Report on PolyMet Tailings Basin Geology and Proposed Engineering Controls

Paula Maccabee
Attorney for WaterLegacy
1961 Selby Avenue
St. Paul, MN 55104

J.D. Lehr
Professional Geologist
P.O. Box 217
Lutsen, MN 55612

Date: January 4, 2022

FIGURE 5. POLYMET’S SCHEMATIC DIAGRAM SHOWING ASSUMED NO-FLOW BOUNDARY WITHIN BEDROCK

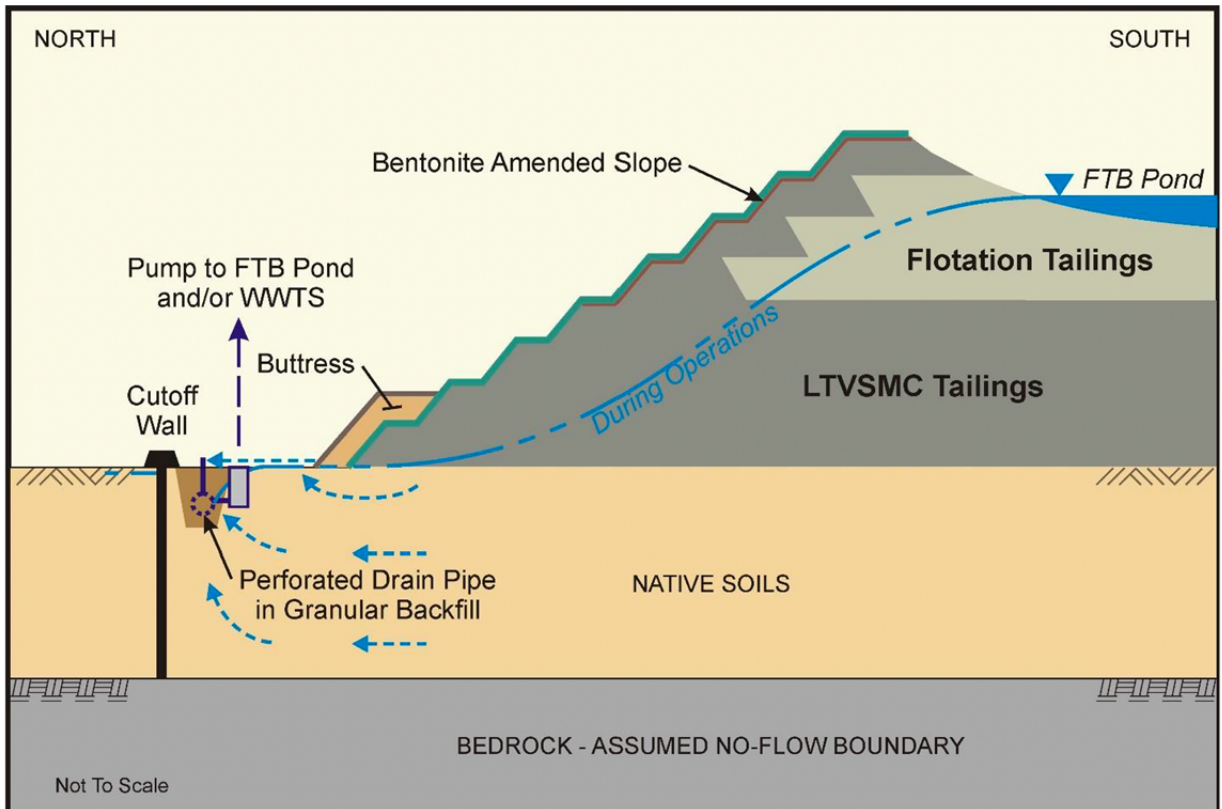
A key component of PolyMet’s proposed seepage capture system is the installation of a continuous bentonite-rich slurry wall¹⁷ (Figure 5) 12-inches-thick along the perimeter of the western, northern and portions of the eastern margins of the existing tailings basin from the land surface keyed into solid bedrock. PolyMet assumes that if installed as described, the bentonite slurry wall will sufficiently prevent the migration of seepage so that all contaminated groundwater as well as surface water can be captured by drain pipes, sumps and pumps installed inside the slurry wall (Figure 5). The efficacy of this seepage capture network will then depend on the ability to maintain inward flowing groundwater pressure necessary for flow to be directed towards the seepage capture portion of the system.

The Geotechnical Report contained in the Permit to Mine Application arrives at the conclusion that only the upper 10 feet of bedrock contains a fracture density significant to groundwater flow and that below that zone bedrock fractures are so insignificant to groundwater flow that “*the bedrock* [beneath and surrounding the tailings basin] *acts as a no-flow boundary*” (Figure 5).^{27, 28} As explained in more detail in Section 5, testing data derived from the 2014 drilling programs at the tailings basin do not support PolyMet’s assumed “impermeable” and groundwater “no-flow” attributes of the bedrock at the tailings basin.

Note: this figure does not show the slurry/cutoff wall “keyed” into bedrock.

FIGURE 6. DRILL HOLE LOCATIONS

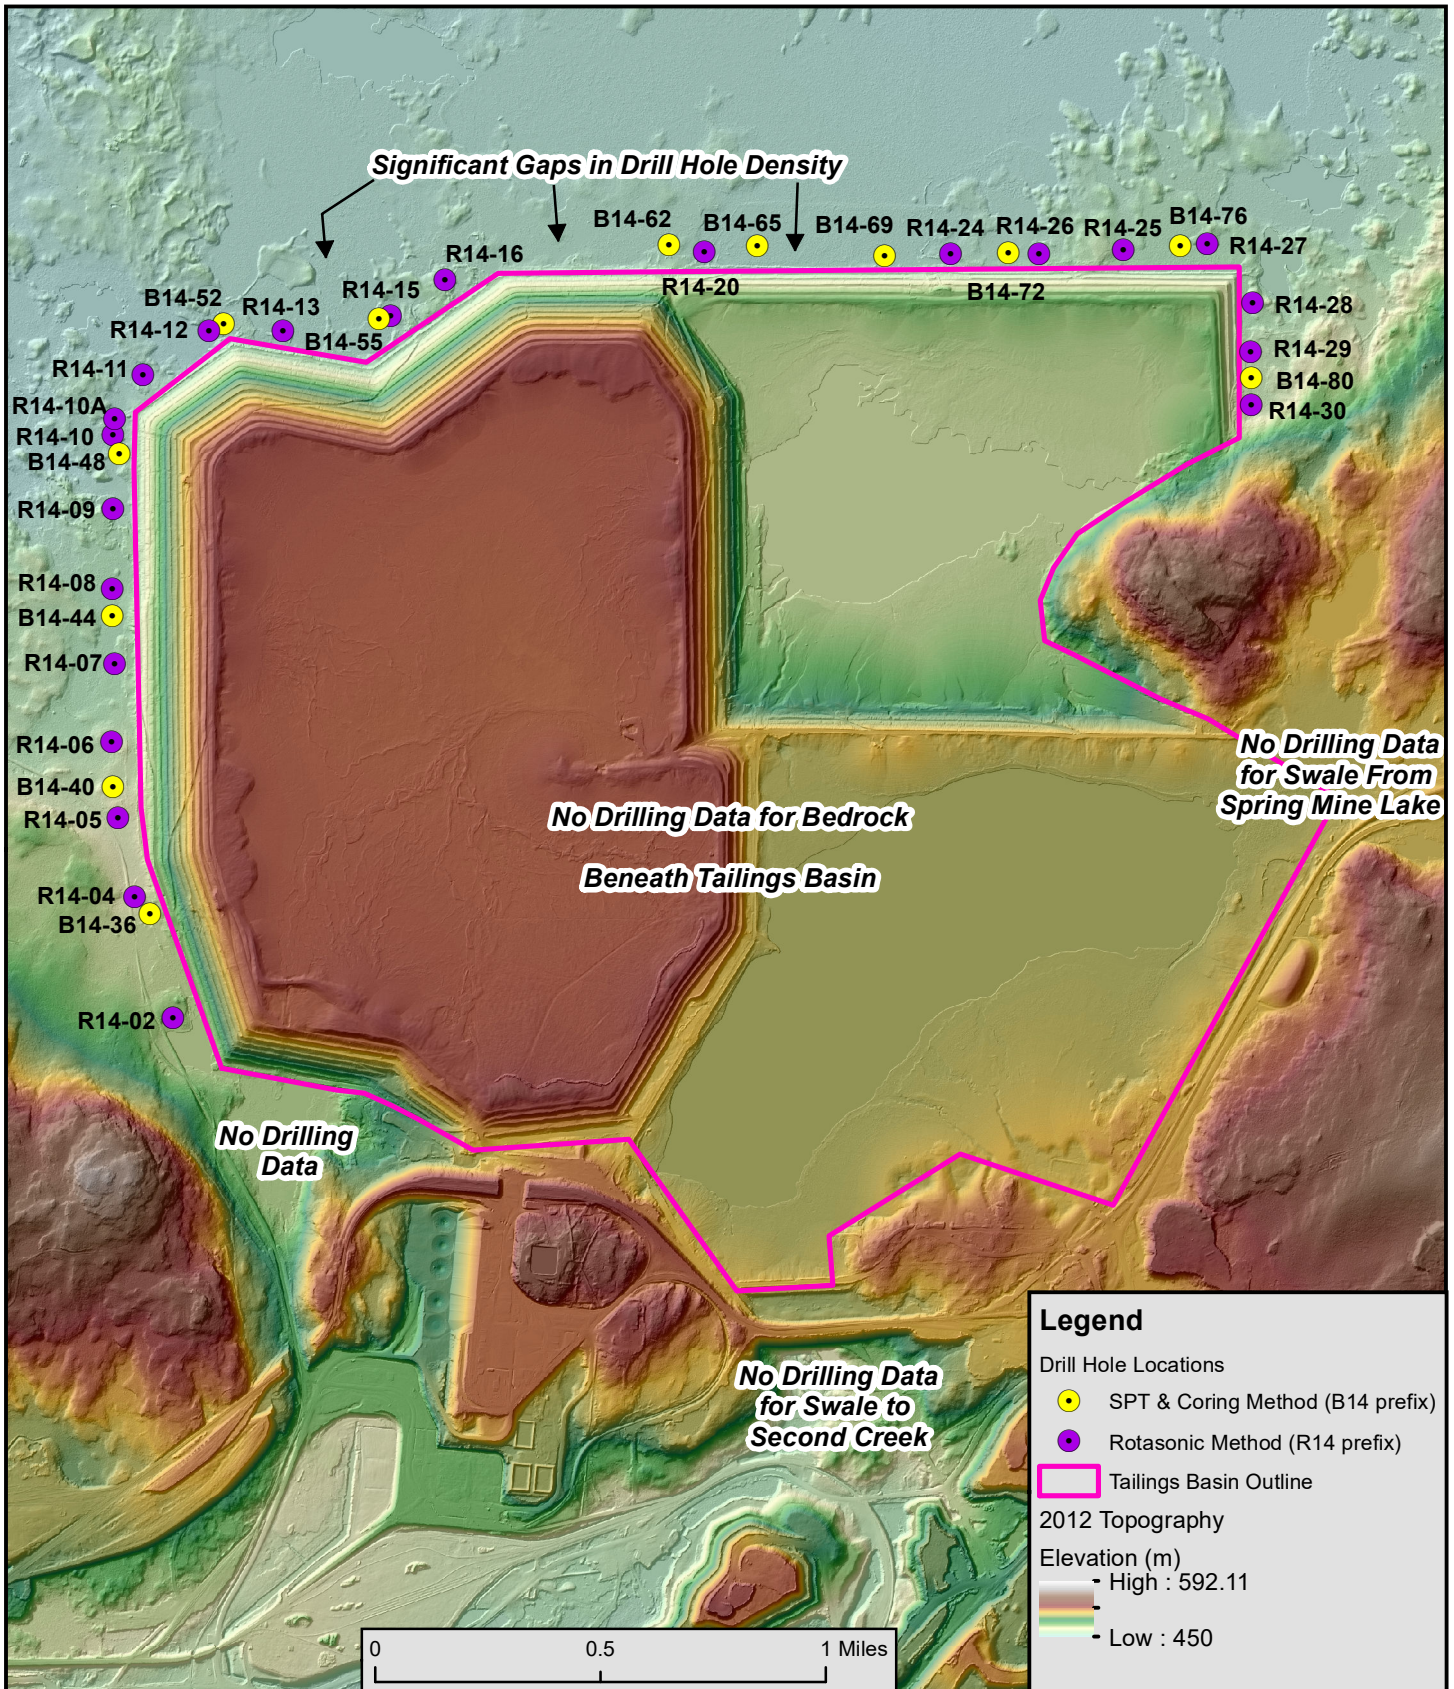
PolyMet’s characterization of the geology beneath the tailings basin and at the seepage capture system perimeter contained in the Permit to Mine Application and related documents is based primarily on drilling and testing programs carried out by Barr Engineering²⁰ during 2014. Results from the 2014 drilling programs are available only along the western, northern, and partial eastern margins of the proposed FTB seepage capture system (Figure 6).

Gaps in the distribution of drill holes along the northern margin of the tailings basin (Figure 6) are explained in the Geotechnical Report as resulting from site access constraints. Along the northern perimeter of the tailings basin a total of 7 of the proposed 30 Rotasonic drill holes⁷⁴ were not drilled because “the proposed locations were not accessible”⁷⁵ “due to open water conditions”.⁷⁶

FIGURE 10. OVERALL WEIGHTED AVERAGE RQD*

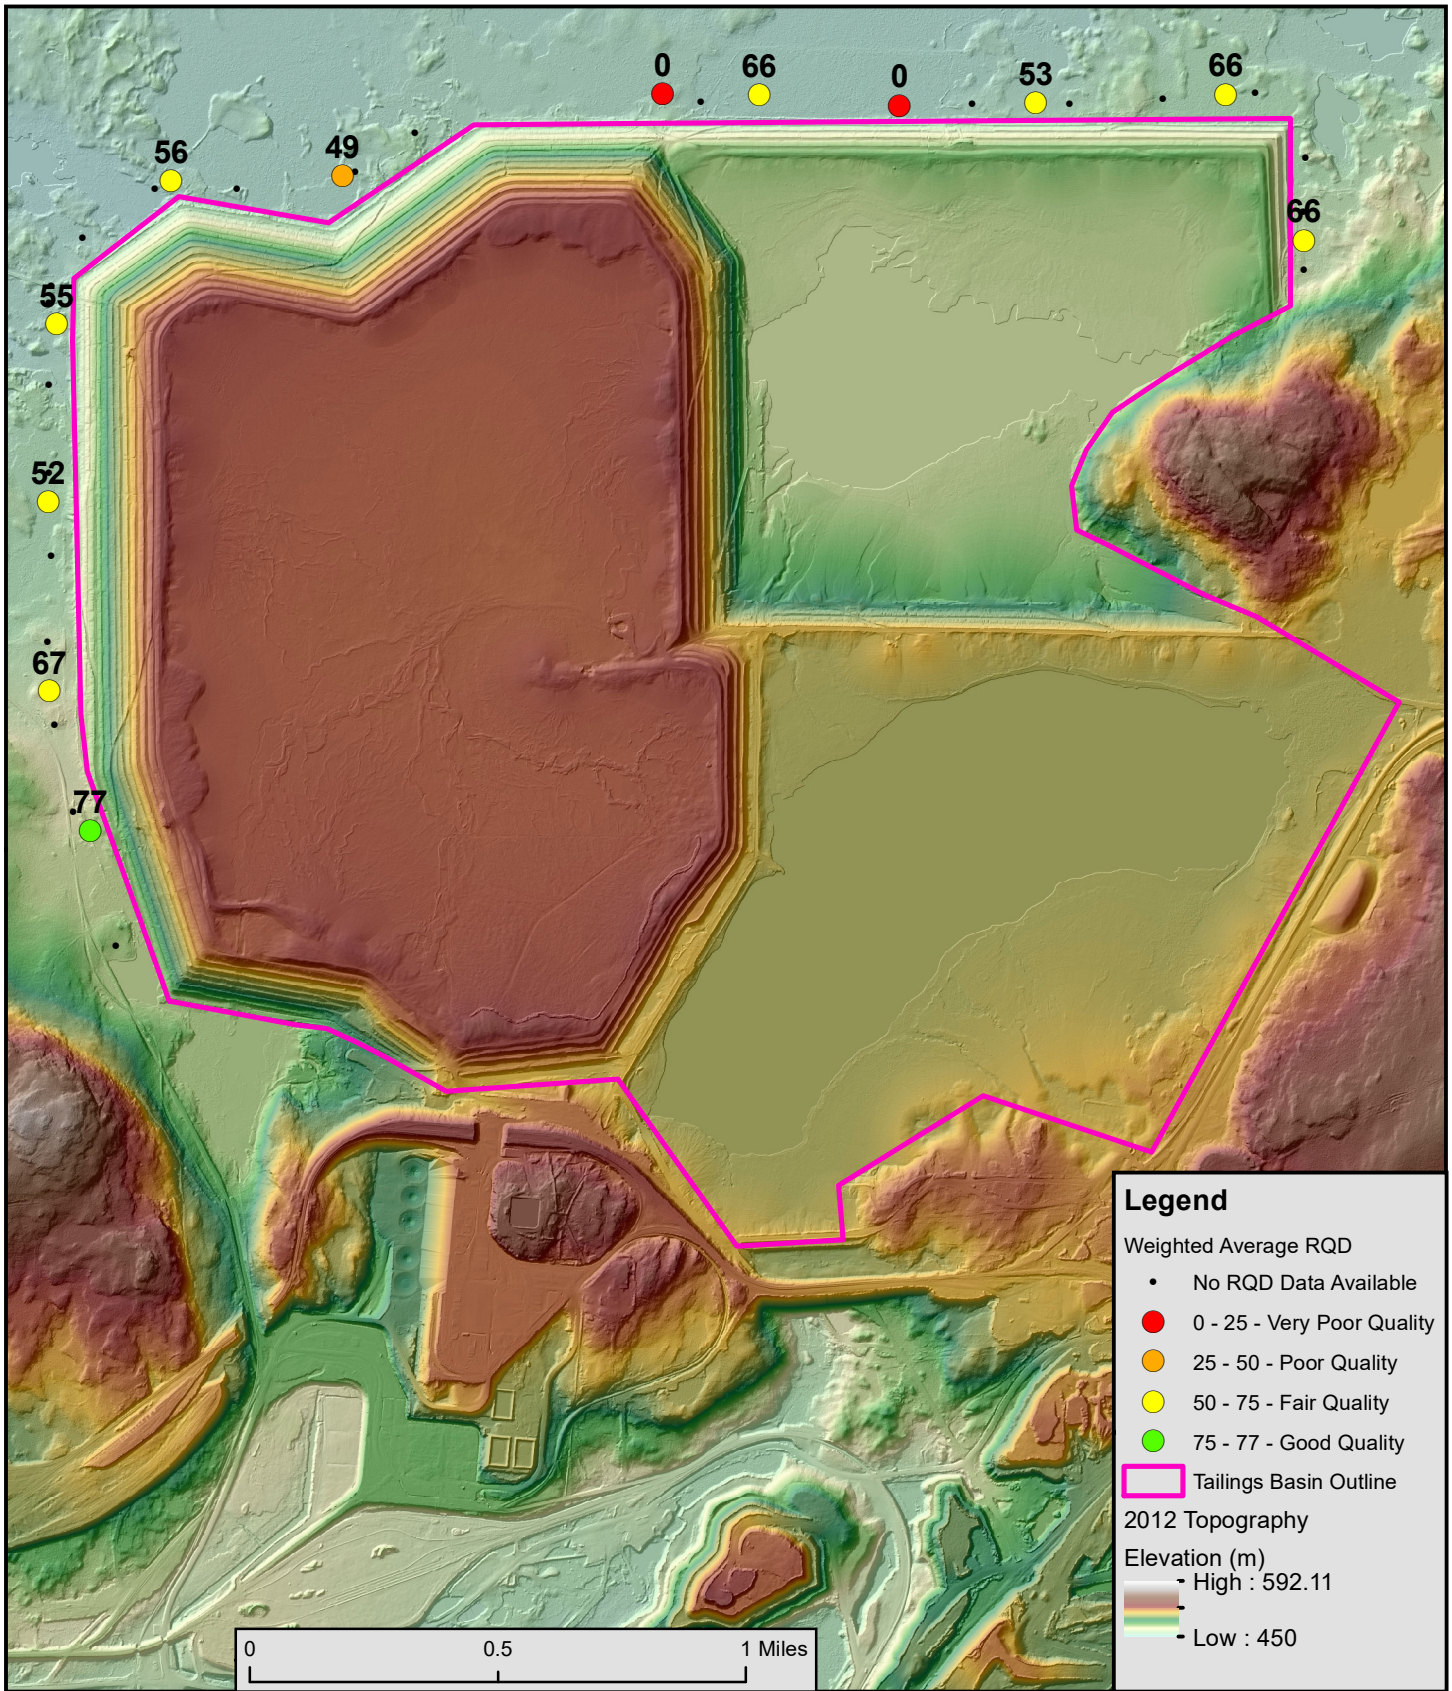
To address whether PolyMet's claim that subsurface geologic conditions will allow for the construction of the seepage capture system is supported, the concerns raised in Section 5 must be reviewed spatially and cumulatively. Mapping of weighted average RQD show areas with the most fractured bedrock are disproportionately concentrated along the northwestern and northern perimeter of the tailings basin perimeter (Figures 10 and 11).

Bedrock with RQD values indicating "good quality" bedrock⁸¹ (RQD = 77) occurs at a single location along the southwestern perimeter of the FTB (the green symbol shown on Figure 10). Note that green symbols are lacking from the entire remainder of the tailings basin perimeter. This leaves an extended segment of the alignment of the proposed seepage capture system where RQD data from every hole drilled show some degree of fractured bedrock throughout the entire interval of bedrock drilled. None of the drill holes yielded RQD results demonstrating fully competent bedrock.

FIGURE 11. WEIGHTED AVERAGE RQD FOR INTERVAL > 10 FEET INTO BEDROCK*

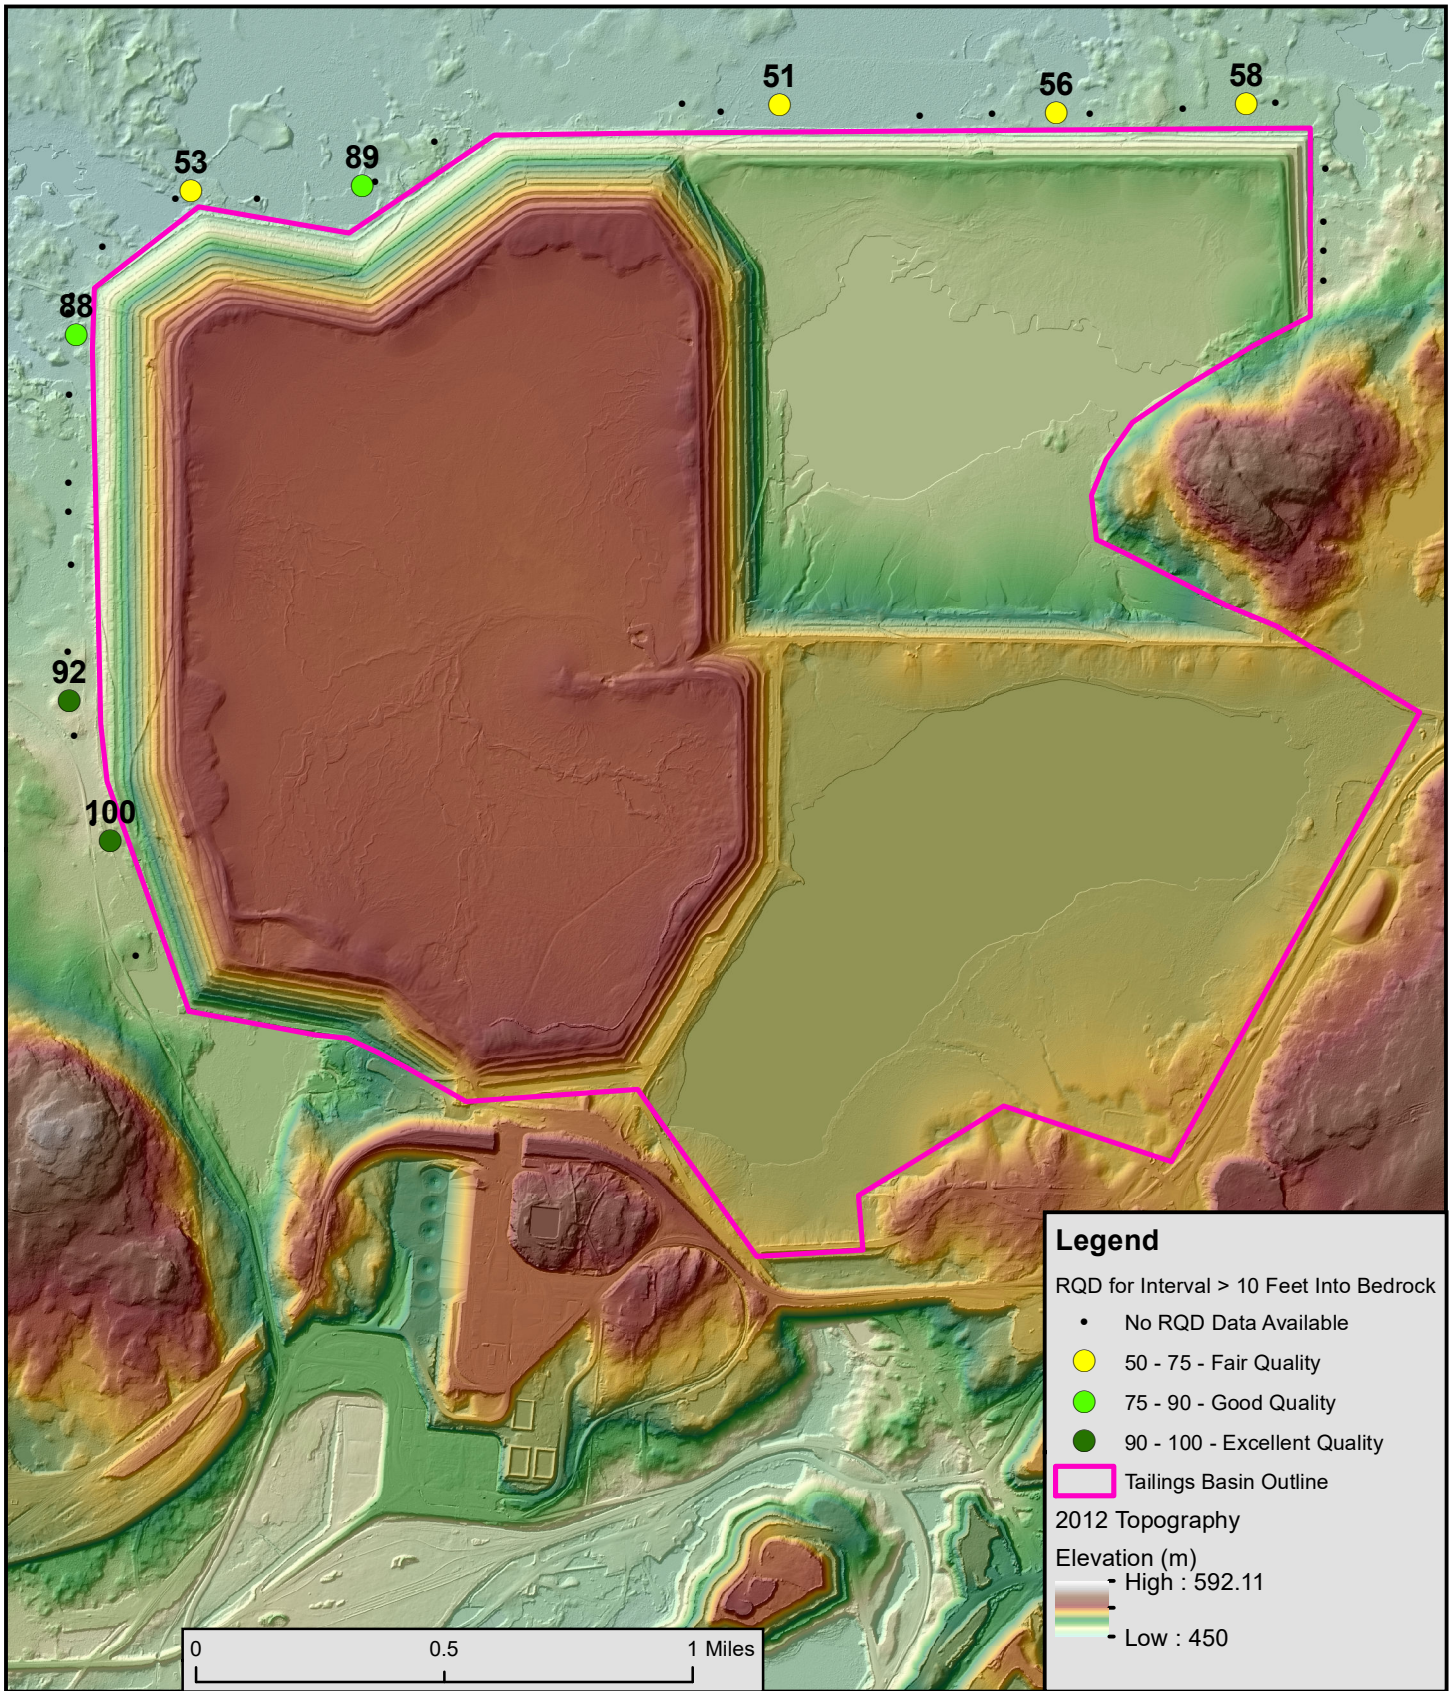
An additional way to identify spatial patterns within the RQD dataset (and therefore patterns in fracture density) is to look at RQD results from only those intervals drilled deeper than 10 feet into bedrock – what PolyMet assumed was a "no-flow boundary". The weighted average RQD's for only those intervals are mapped on Figure 11. For RQD data to support PolyMet's claim of a "no-flow" zone, all of the RQD values shown on Figure 11 should approach 100.

Several RQD data points from the western (LTV) side of the tailings basin show average RQD values ranging from 88 to 100, indicating "good to excellent quality" bedrock at >10 feet, although one drill hole showed an RQD of 53 indicating only "fair quality" bedrock (Figure 11). The caveat is that these results represent literally only a few feet (3-8 feet) of bedrock in each hole. Since only a few feet of sound bedrock was drilled at so many locations; many of these reported RQD results could in fact represent boulders within glacial sediments rather than bedrock. Additionally, there are many areas where no RQD data are available from the deeper interval, resulting in limited direct information on the frequency of deeper bedrock fractures.

North of PolyMet's proposed FTB, a striking pattern is revealed. All of the available RQD data for over the entire mile-and a quarter-long stretch of the northern margin of the FTB show the deeper bedrock

to contain only “fair quality” bedrock with RQD values from 51 to 58 (Figure 11). These are 3 of the 4 lowest RQD values reported anywhere from the interval more than 10 feet below the top of bedrock. They indicate extensively weathered and fractured bedrock and the potential for more groundwater to seep below the bentonite slurry wall through these areas which are not “impermeable”. Neither the Final EIS nor PolyMet’s modeling considered this seepage.⁸²
